Report to the Future Melbourne (Planning) Committee

**Ministerial Planning Referral: TPMR-2016-23/A
681-693 Collins Street, Docklands
Melbourne Quarter Tower (Stage C2)**

16 April 2019

| Proposal: | Proposal to amend Planning Permit PA1600147 and associated plans in relation to a revised Melbourne Quarter Tower (Stage C2) development proposal. |

5 SEP 22 12hs

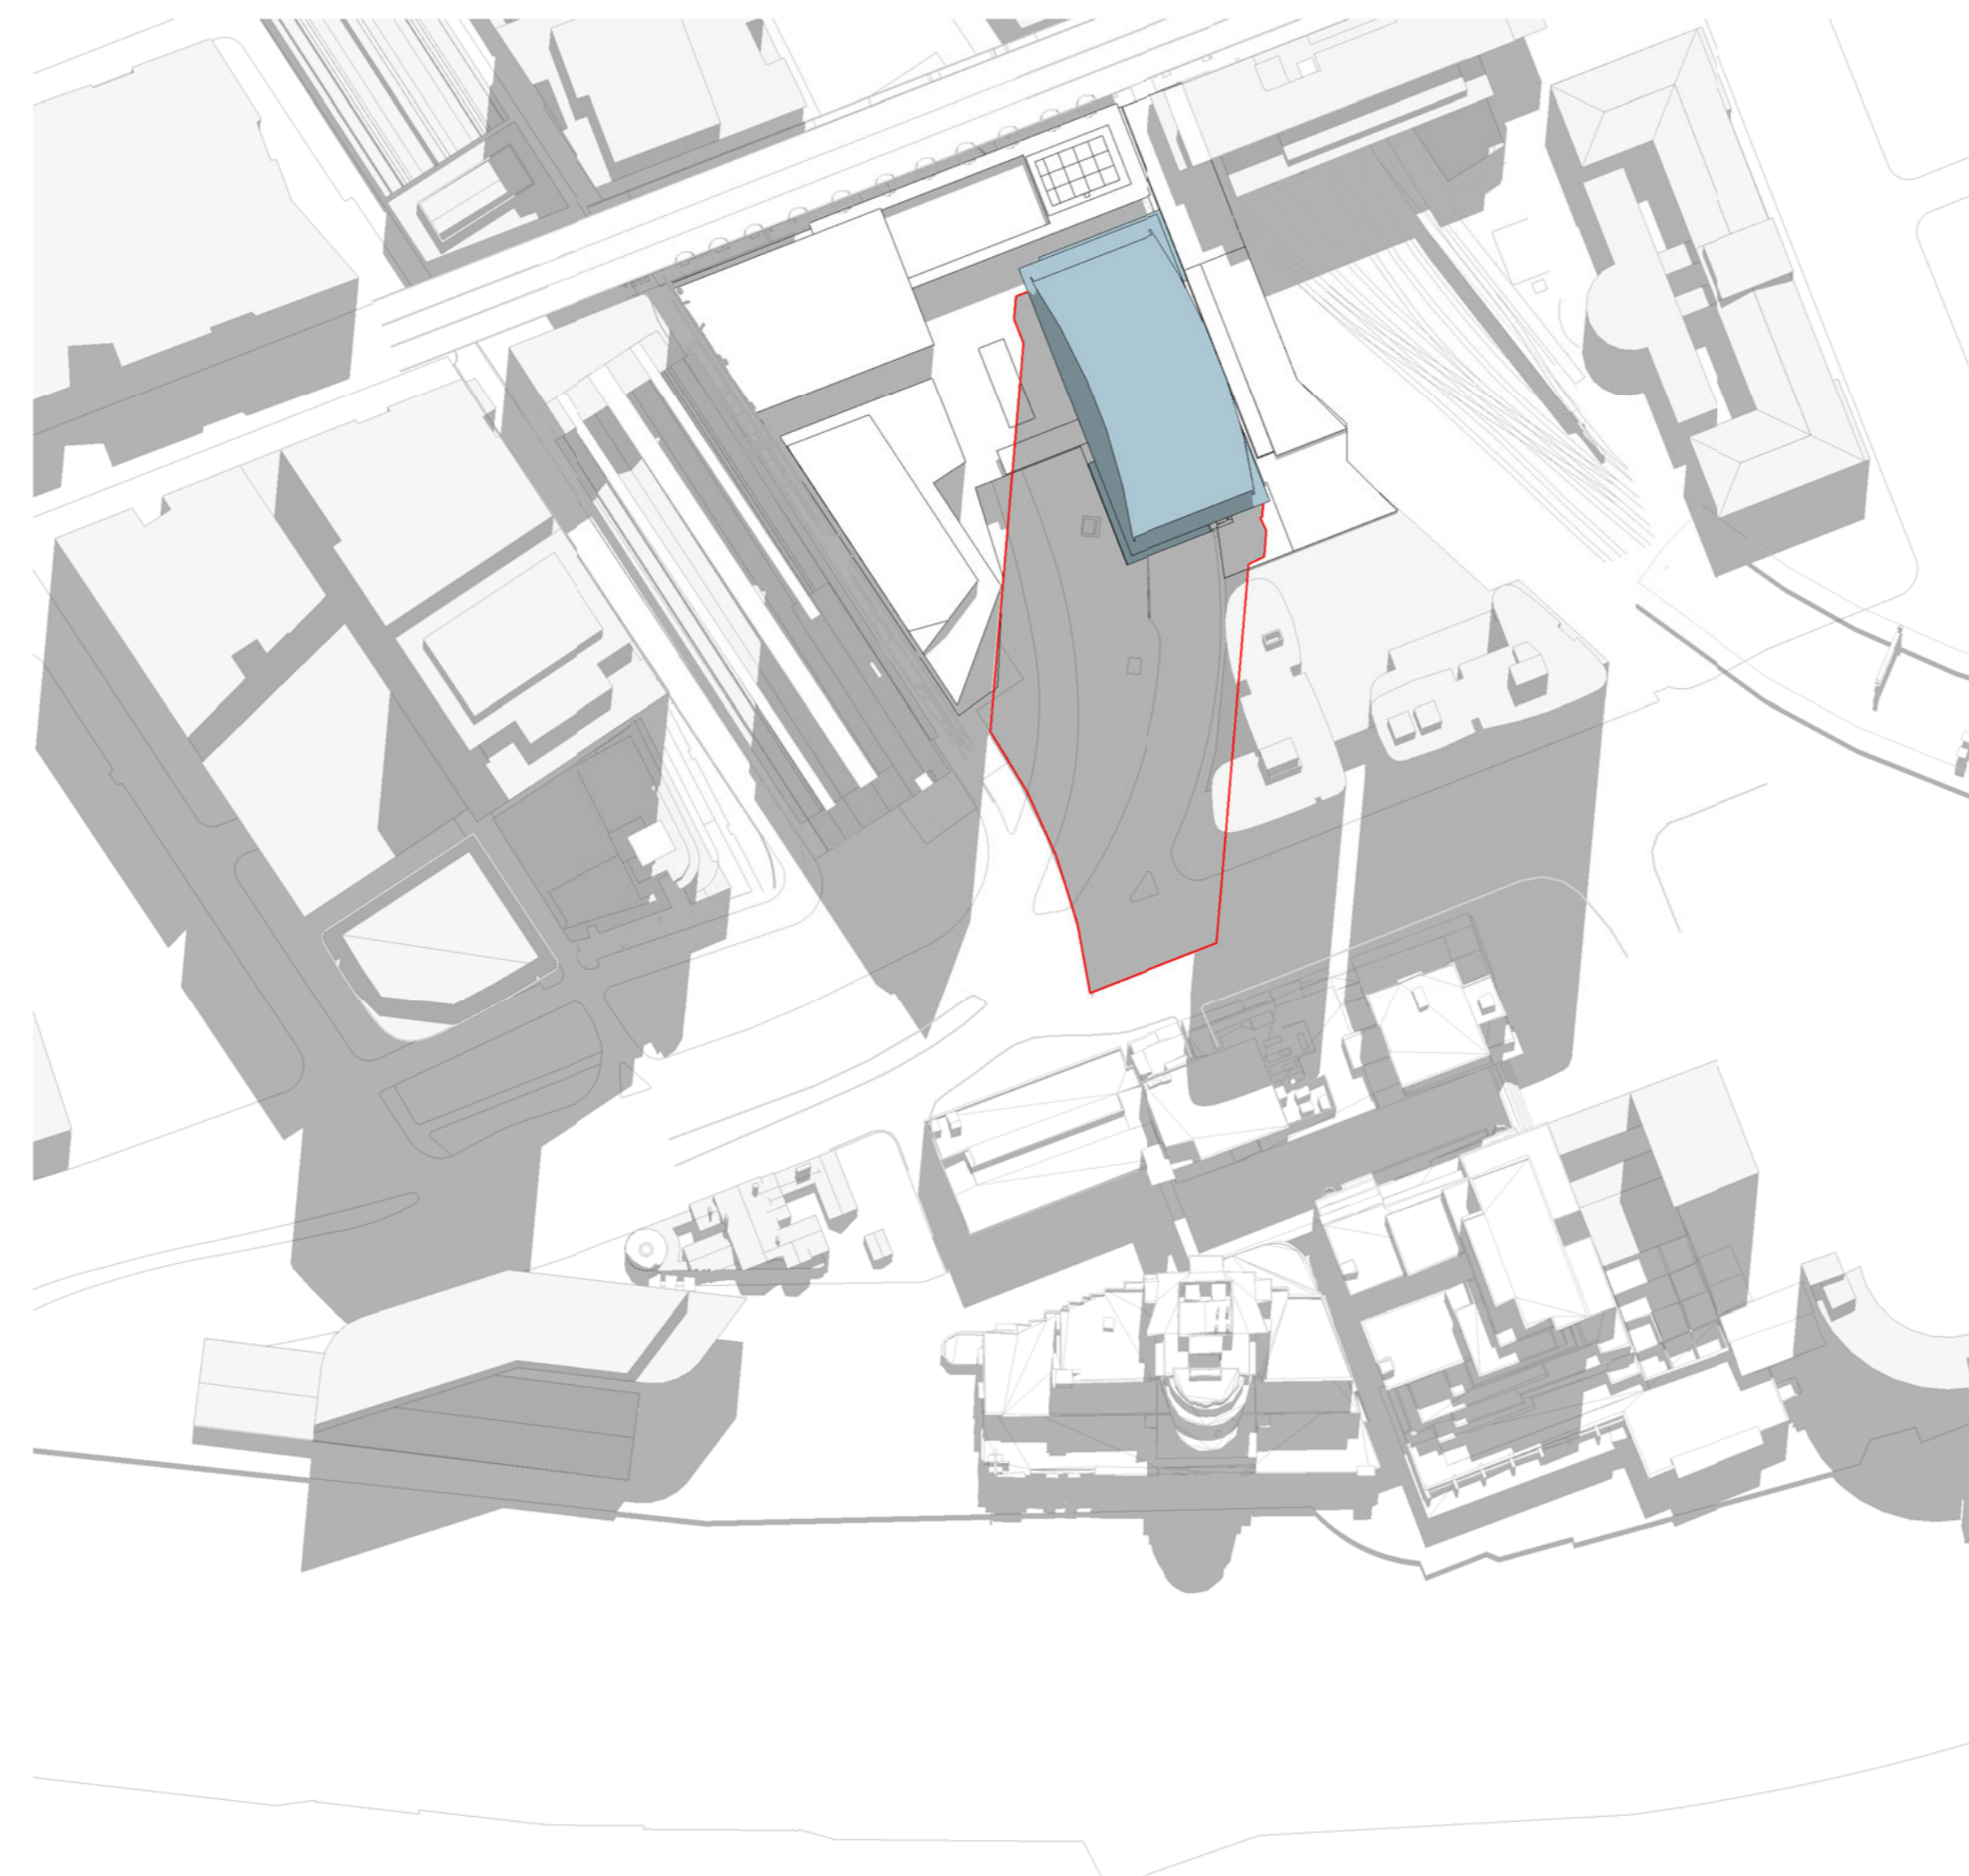
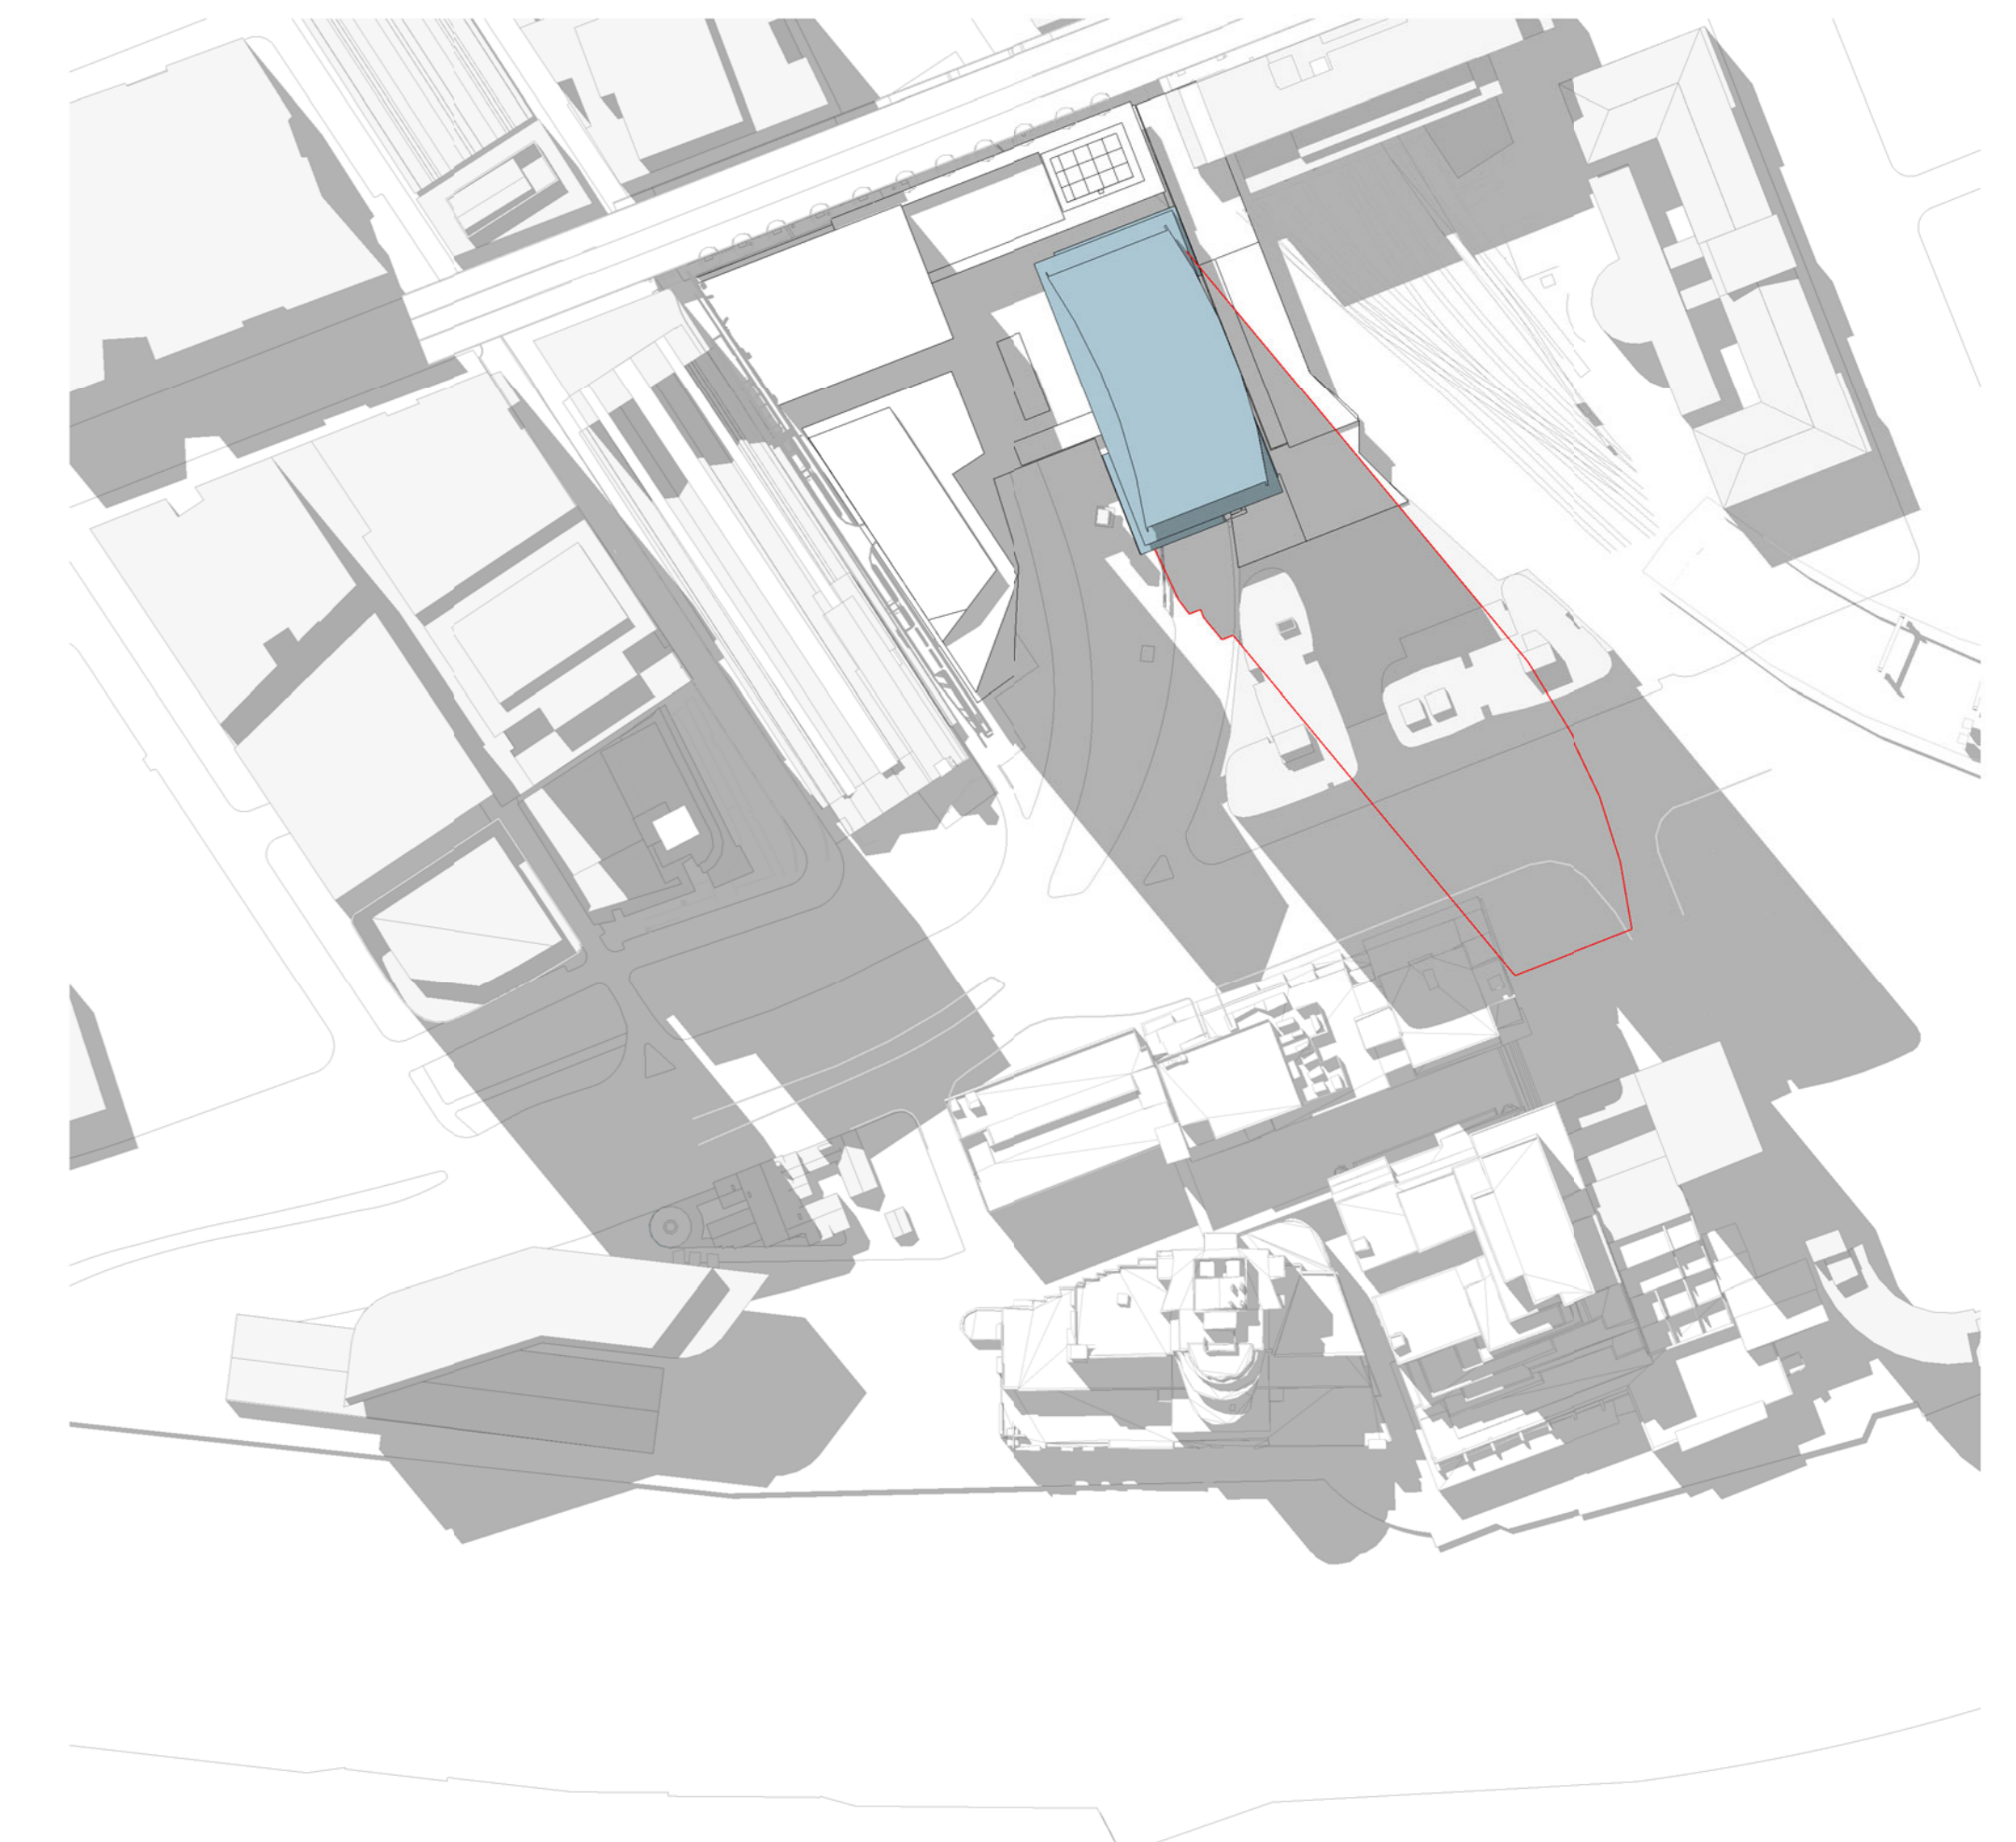
9. The overshadowing is compliant with the requirements of the development plan. Equally, wind impacts are considered to be appropriate and consistent with the development plan.

FIGURE 4: SHADOW IMPACT AT 12PM ON 22 JUNE

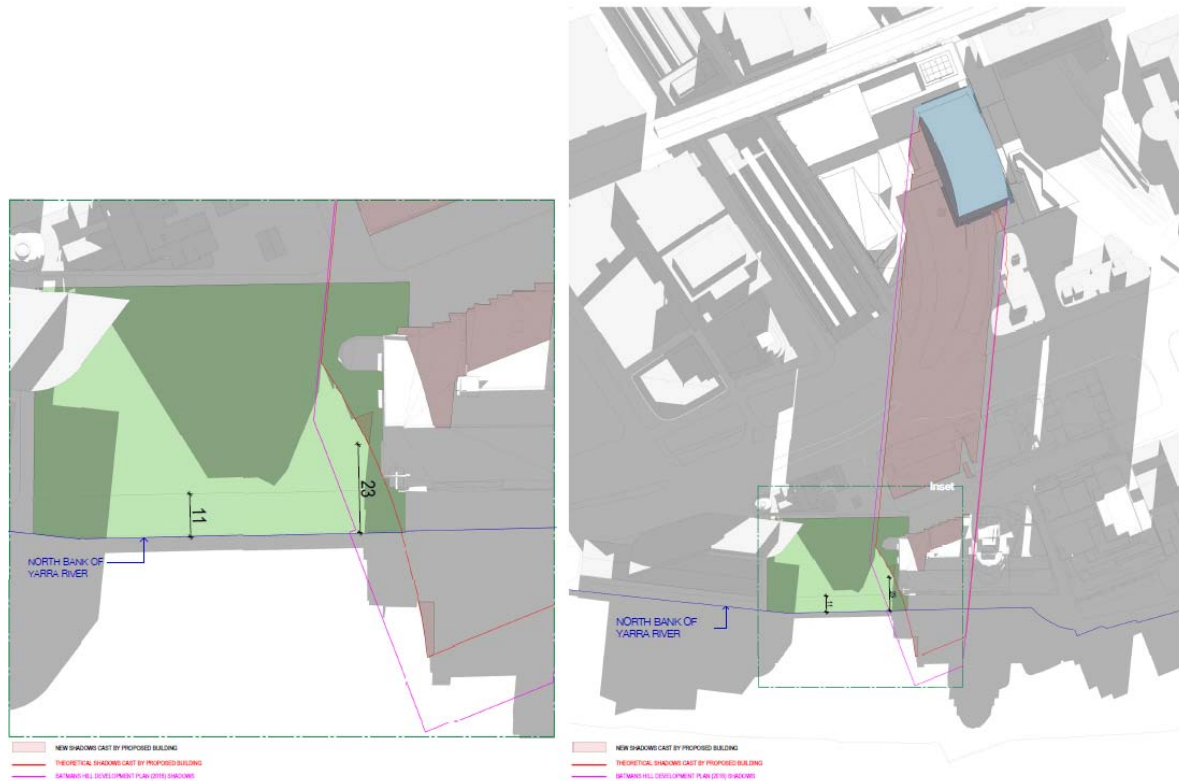
Nonetheless, even if the same criteria that the Minister used to approve 2MQ is applied (i.e. no overshadowing of Seafarers Rest park within 11m of the north bank at 12 noon on the winter solstice), the new shadows also comply with that test.

This is demonstrated in the below detailed shadow drawing provided by the applicant. The new shadow (shown by red hatching) only affects a very small section of the park at the specified time, and it is much more than 11m from the north bank at 23m.
